Karen Bokor, B.S., M.Arch.
DESIGN CONSULTANT

HISTORICAL ANALYSIS AND DESIGN REVIEW:

Project: COhatch Riverview Village
Property Addresses: 37 N Riverview Street,
45 N Riverview Street,
53 N Riverview Street,
62 N Riverview Street
Stone structure south of 62 N Riverview
Dublin, Ohio 43016
Owner: COhatch
Applicant: Tim Lai ArchitecT

45 N Riverview Street:

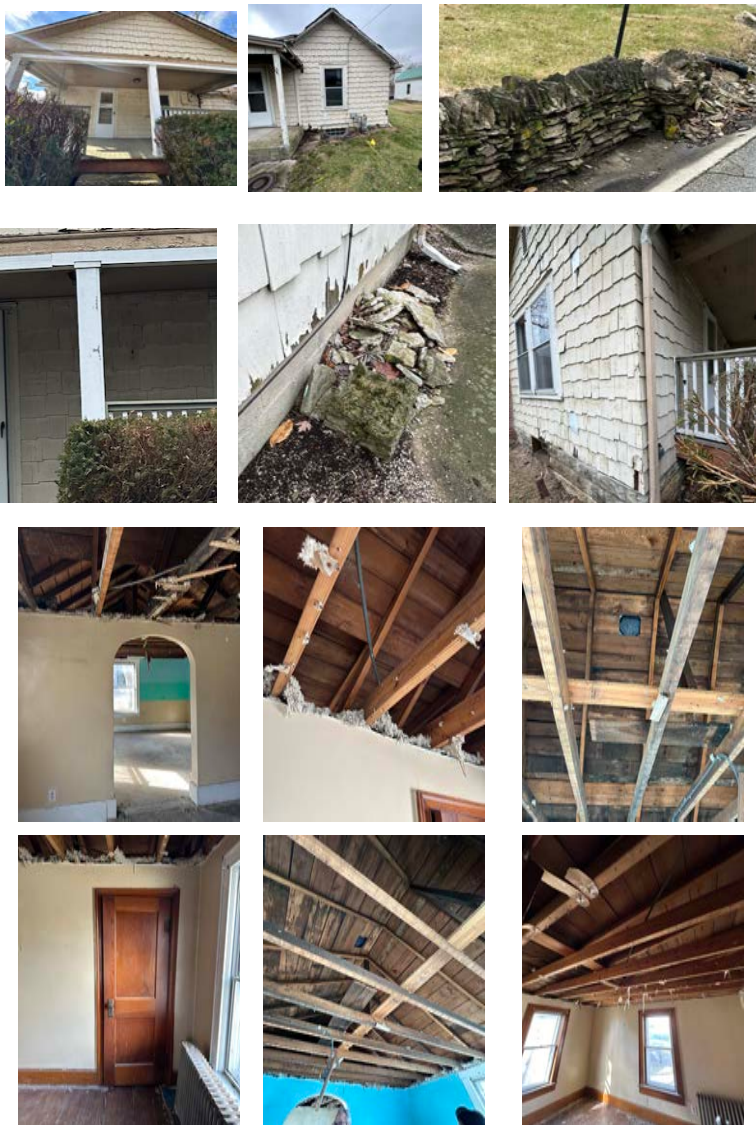
This home is a charming early 1900 structure and will be a great tribute to historic Dublin within the new Riverview Village project. As much as the the original structure should be repaired and restored as is possible.

In the conceptual drawings there are minimal changes. The enclosed porch would remain, the metal columns would be replaced with wood ones, and the stone water table will be extended to skirt the porch. The original wood siding would be restored, repaired or replaced as needed and darker paint colors are proposed.

53 N Riverview Street:

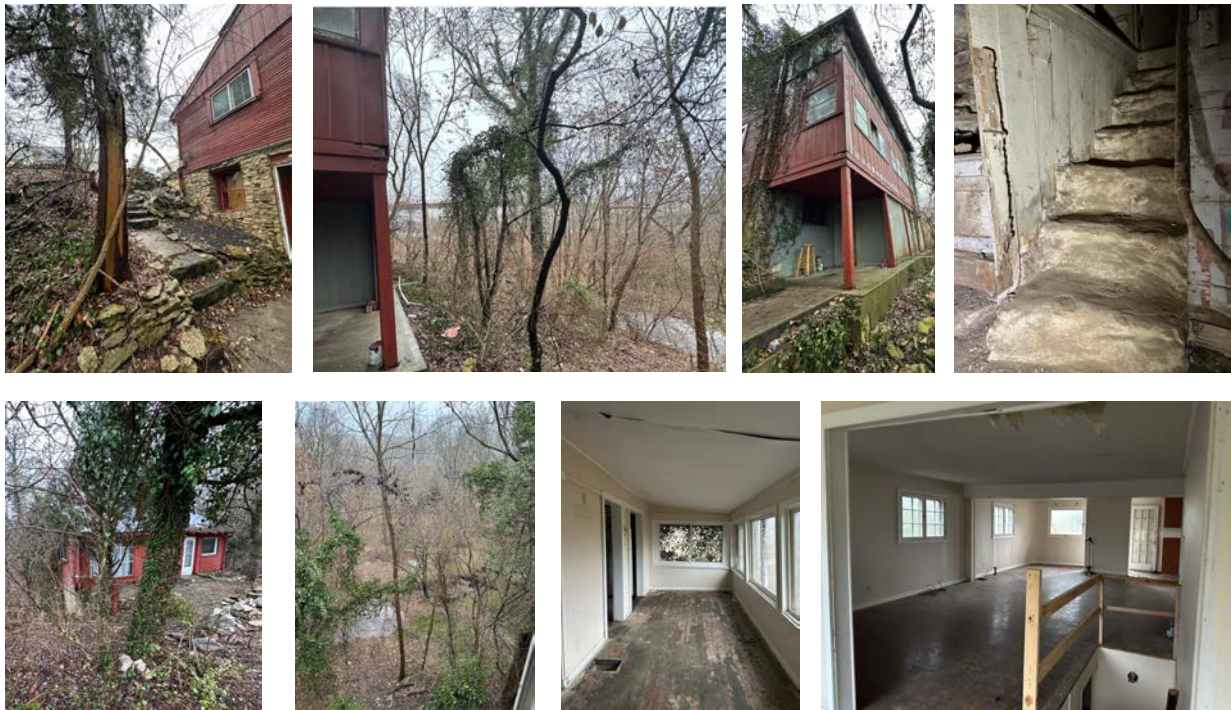
Below are side by side comparisons of the existing structure and the proposed changes. Of all of the existing structures this one will undergo the most change to the original structure. All of the changes are an improvement as this structure is the one in most disrepair. The low porch ceiling will be opened and the porch gable will be detailed as a Craftsman-style gable roof with exposed timbers. A new window on the north elevation will provide more balance below the gable. Additionally, the flat roof will be changed to a mansard roof allowing greater height on the interior. These conceptual changes seem both reasonable and good as this structure does not have the charm or historical significance of the others but DOES have great interior space.
